DOCUMENT 009113.01 – ADDENDUM 01

- A. Project Name: Middle Park High School Summer 2026 Renovation
 - 1. Owner: East Grand School District No. 2
 - 2. Owner Project Number <Owner Project Number>.
 - 3. Architect: Hord Coplan Macht (HCM).
 - 4. Architect Project Number: 222000.30

3 HEATING WATER FLOW DIAGRAM - CONDENSING BOILER PRIMARY/SECONDARY

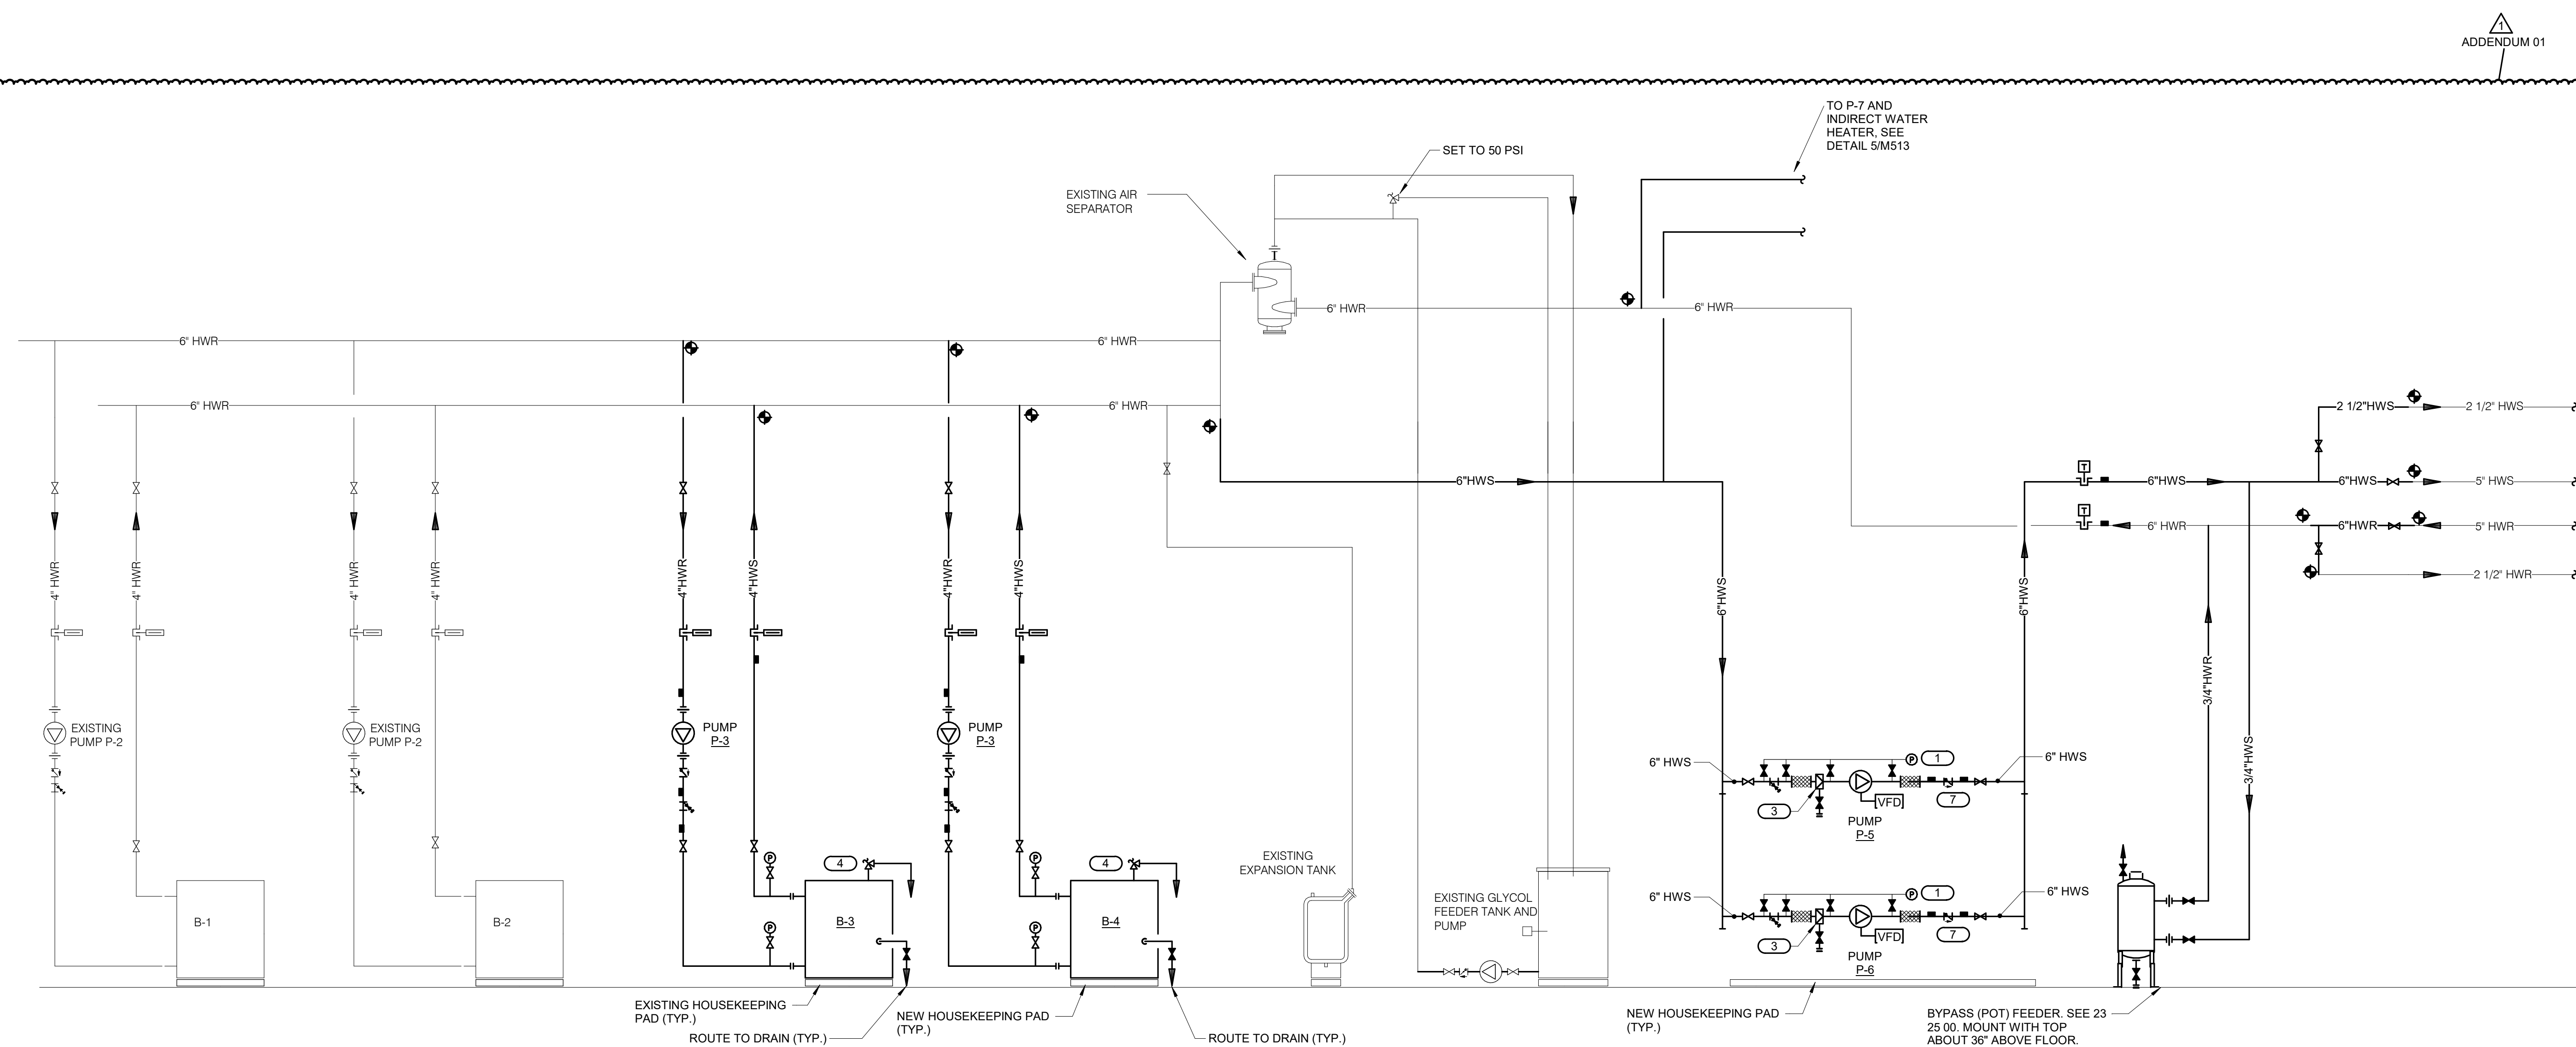
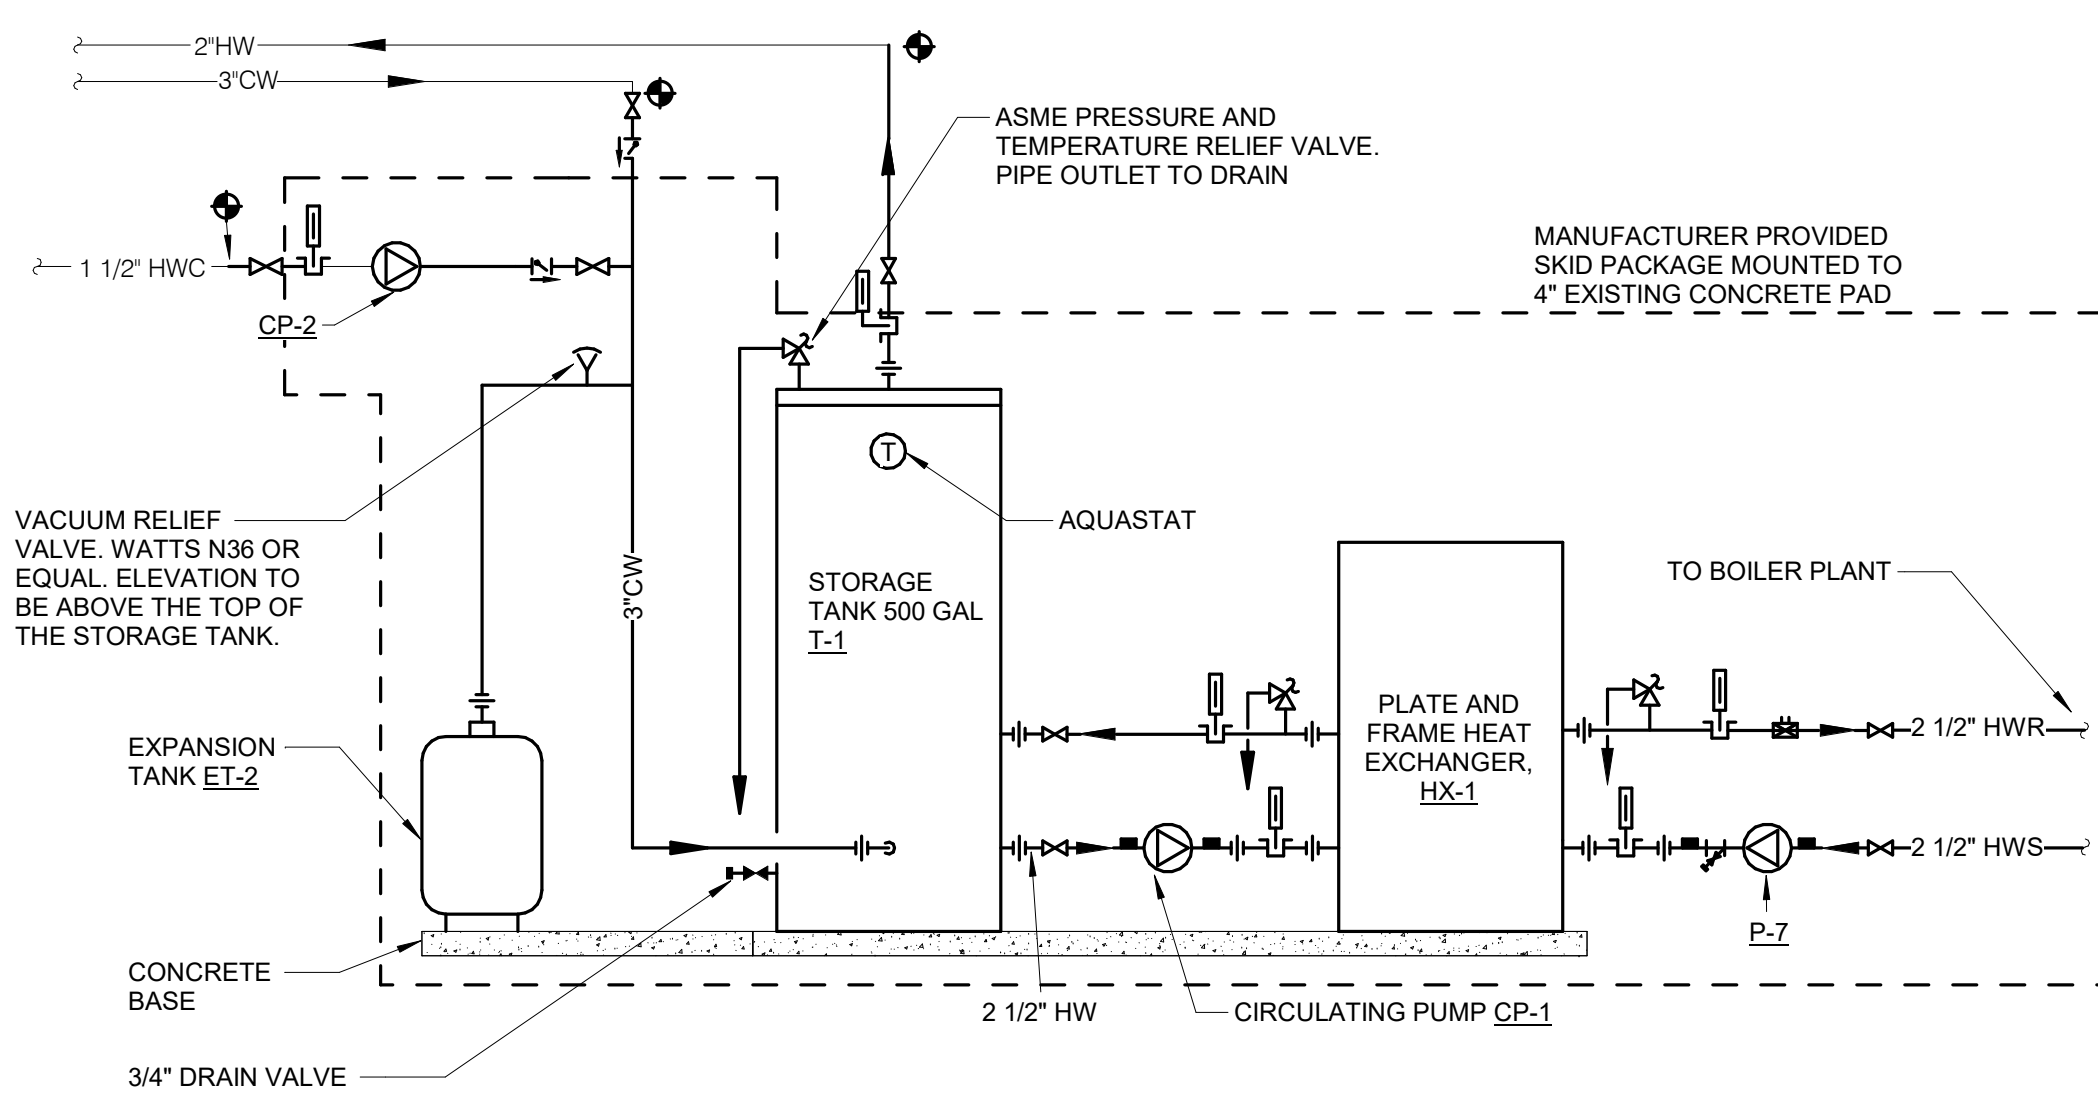
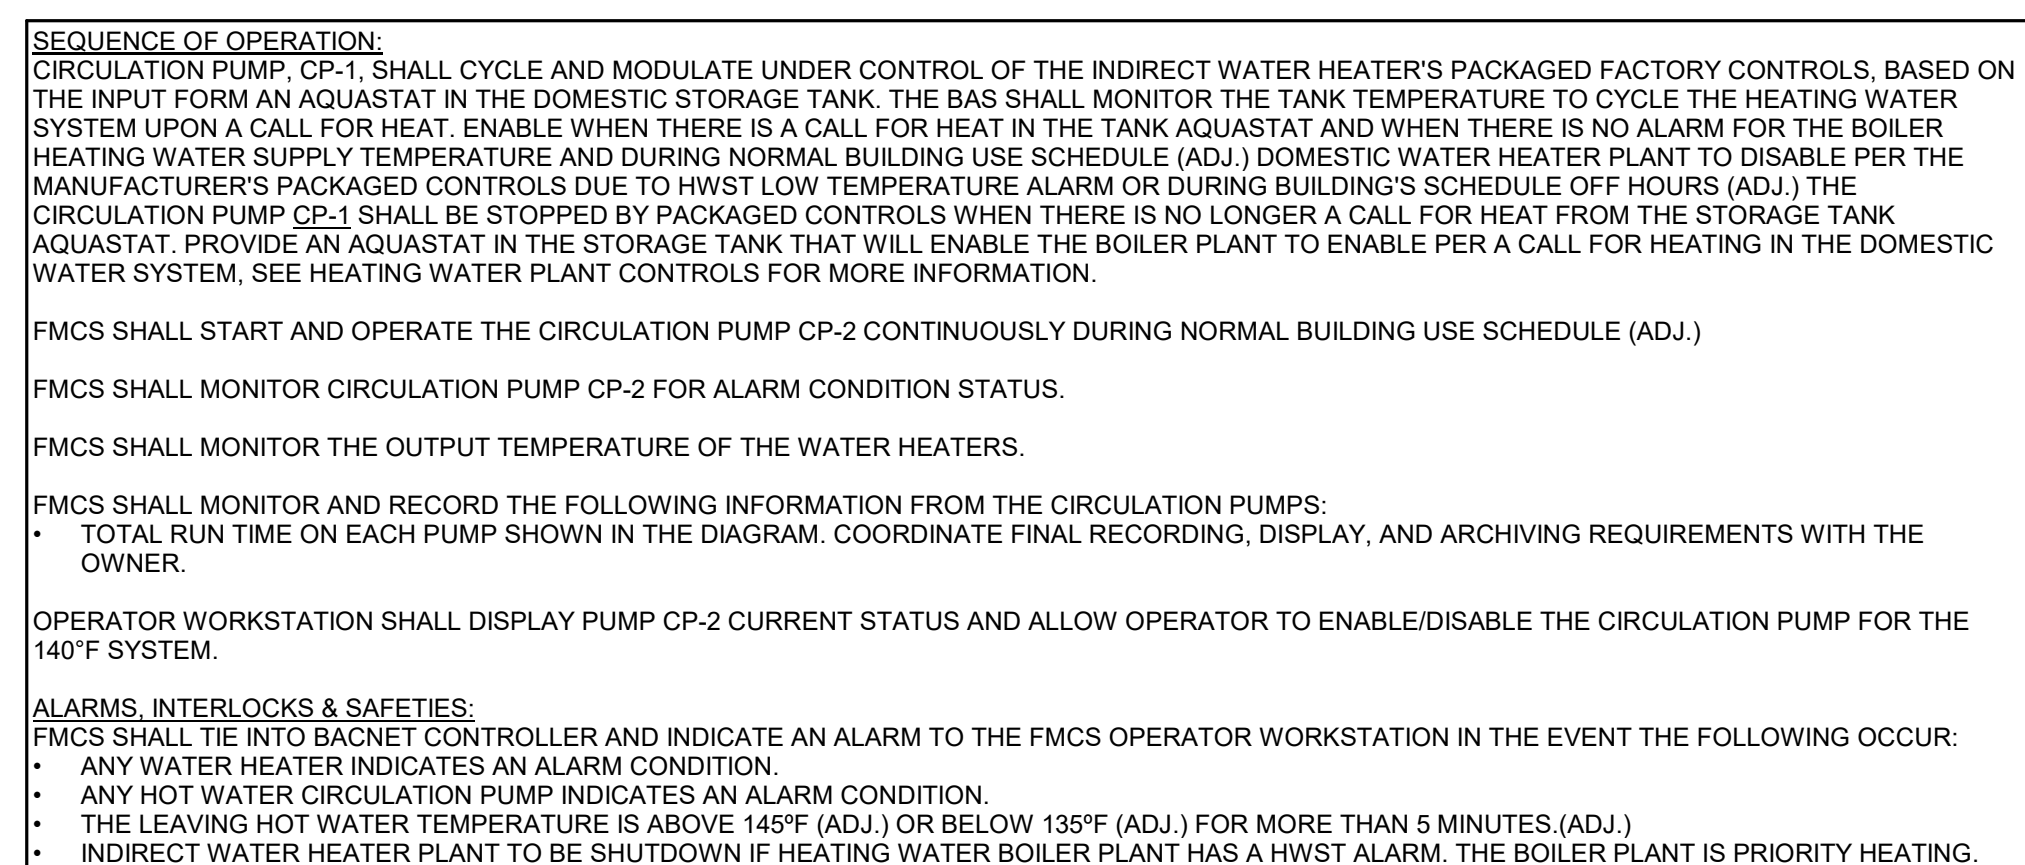
- E. Revision to sheet M-513

- 1. Revision to Heating Flow Diagram.
- 2. Revision to Indirect Water Heater Detail.

M-612

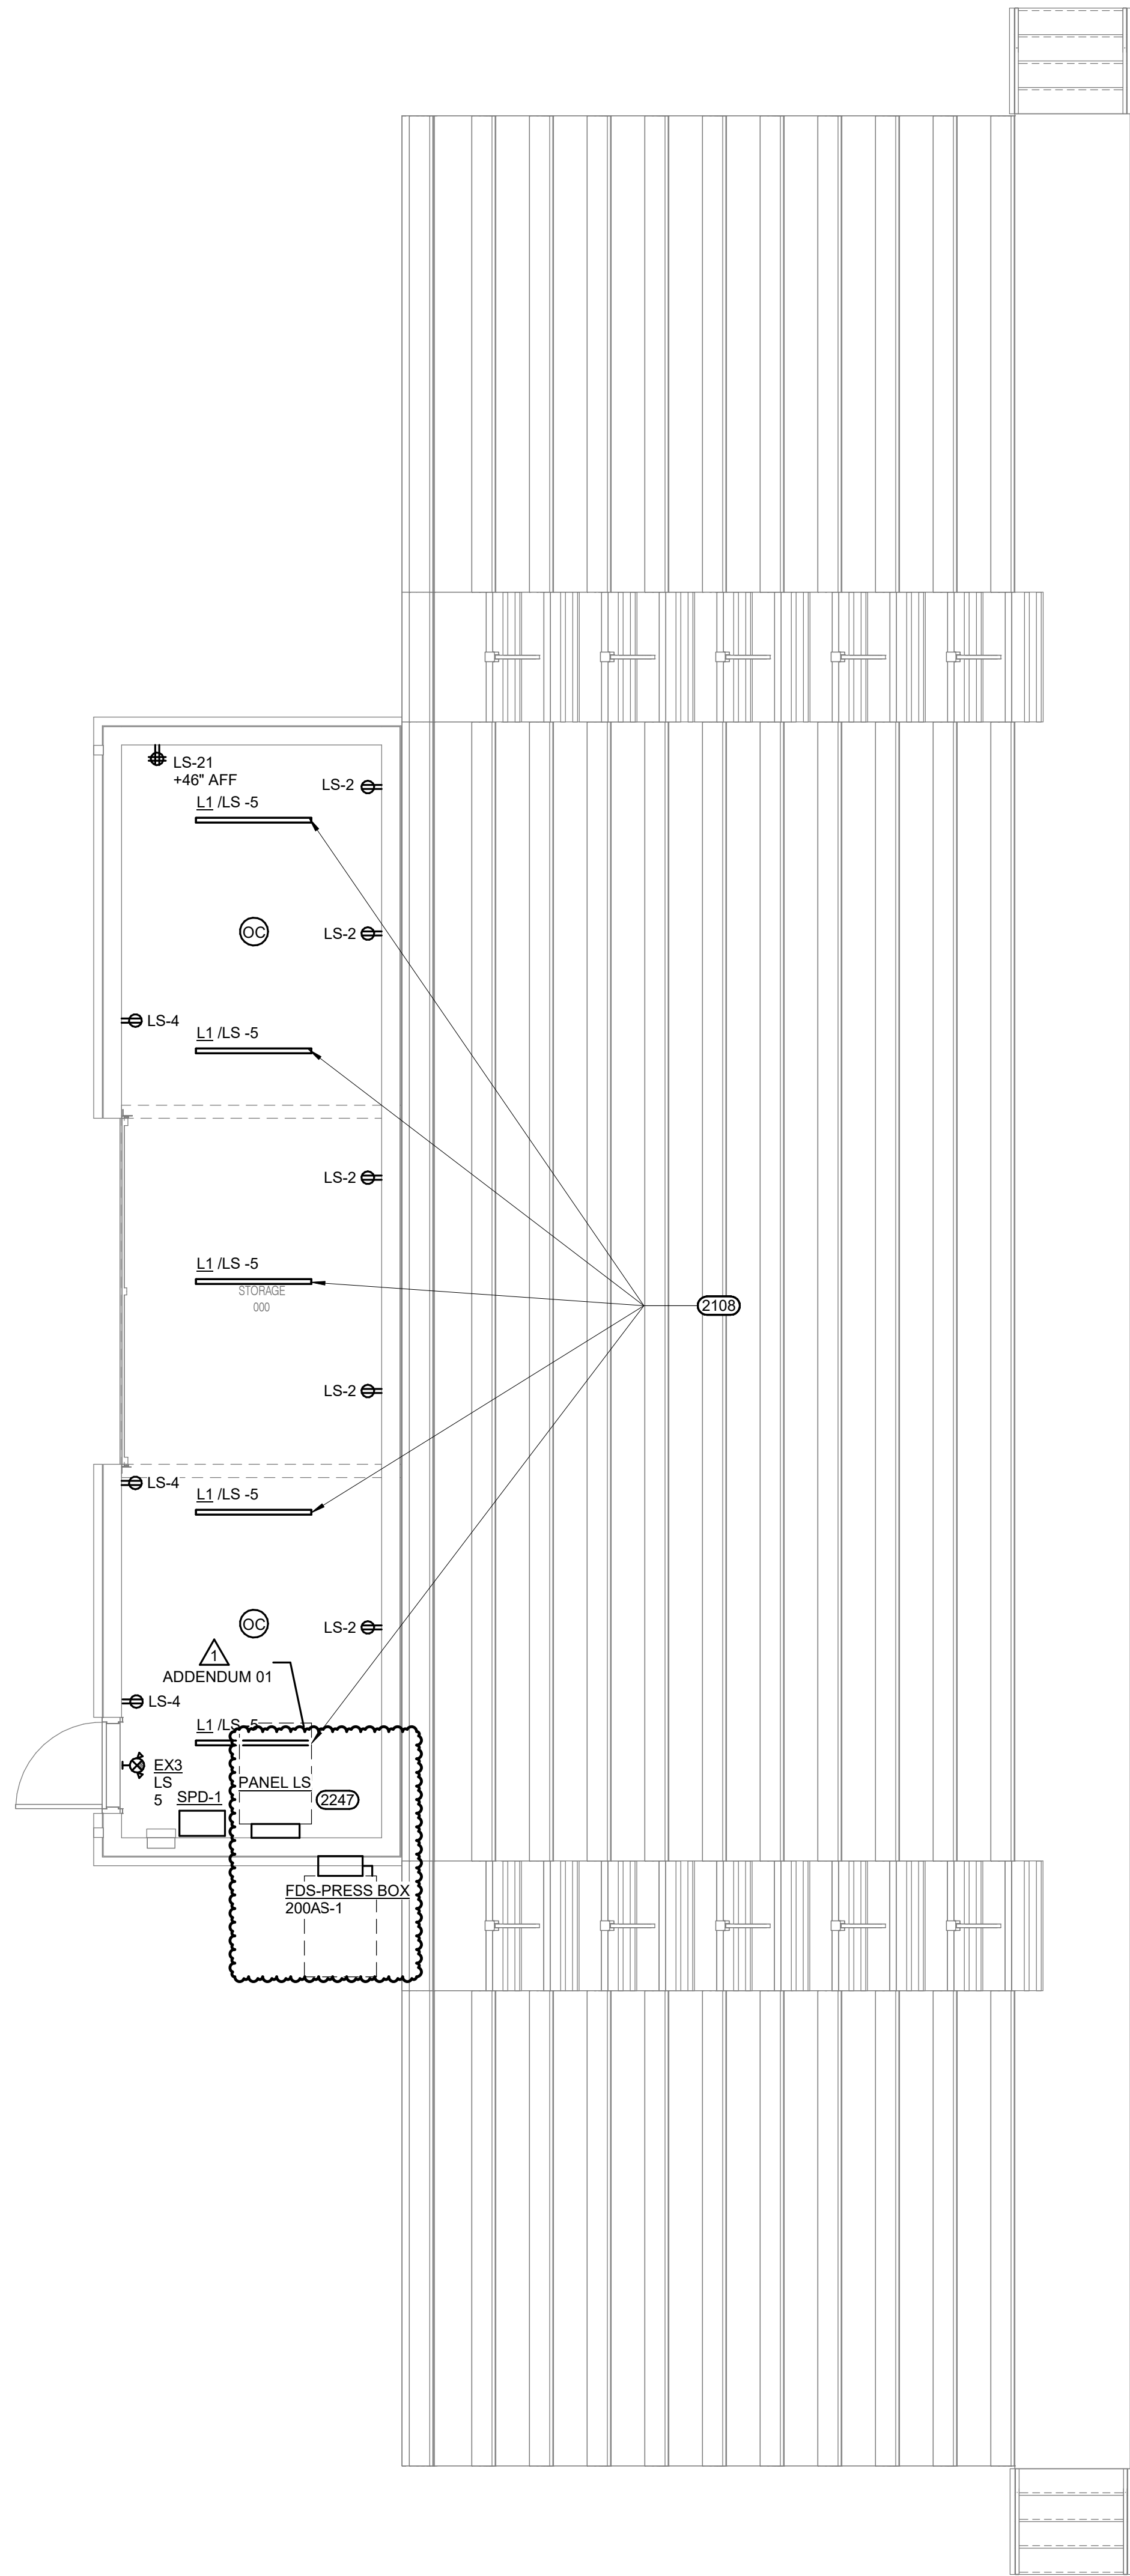
- H. Revision to sheet M-612.

1. Revision to existing air handling unit refurbishment schedule.
 2. Add existing terminal unit refurbishment schedule.
- I. Revision to sheet E-100.
1. Remove TR-LS.
